#### No. EL/3.1.35/2 Electrical

# MODIFICATION SHEET NO. RDSO/2009/EL/MS/0375 (Rev.1), Dated 28.09.12.

Provision of MCB (128.1) in Air Dryer circuit of 3-Phase electric locomotives.

Amendment-1 of circuit diagram for 3A MCB for Air Dryer

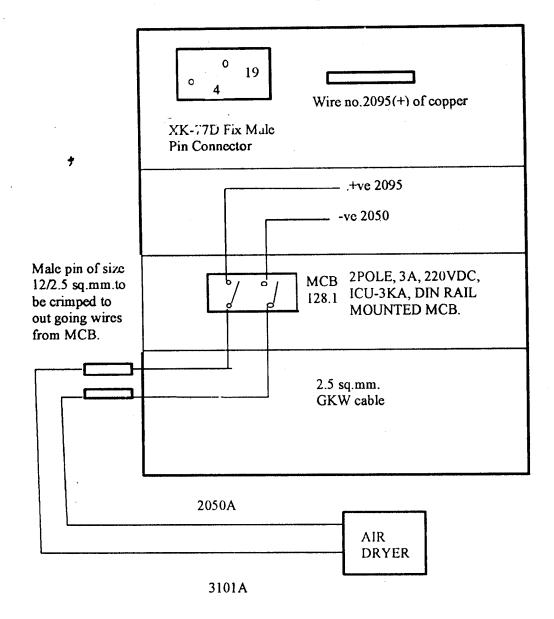
- 2.4 In this connection, SCR has proposed that MCB 128.1 provided in series vide above modification sheet may be provided in parallel so that any fault in Air dryer circuit shall results in tripping of MCB 128.1 only.

The following steps are to be taken for provision of MCB (128.1) switch in parallel with MCB 127.7 for air dryer:

4.2. In SB-2 panel, there is a copper strip for wire no.2095(positive)and negative SB-2 for wire no. 2050 which is to be connected to inputof MCB 128.1.In movable conk XK77D pin no. 4 wire no. 2050 is(negative) and pin no. 19 wire no.3101 is positive. Pin no. 4 and pin no.19 have to be removed from movable conk along with pin. Male counterpart of this pin have to becrimped to out going cable from MCB (128.1). Connections to the respective terminals shall be madeby inserting male female pins and shall be secured with the help of heat shrink sleeve.

The modified circuit is enclosed as Annexure.
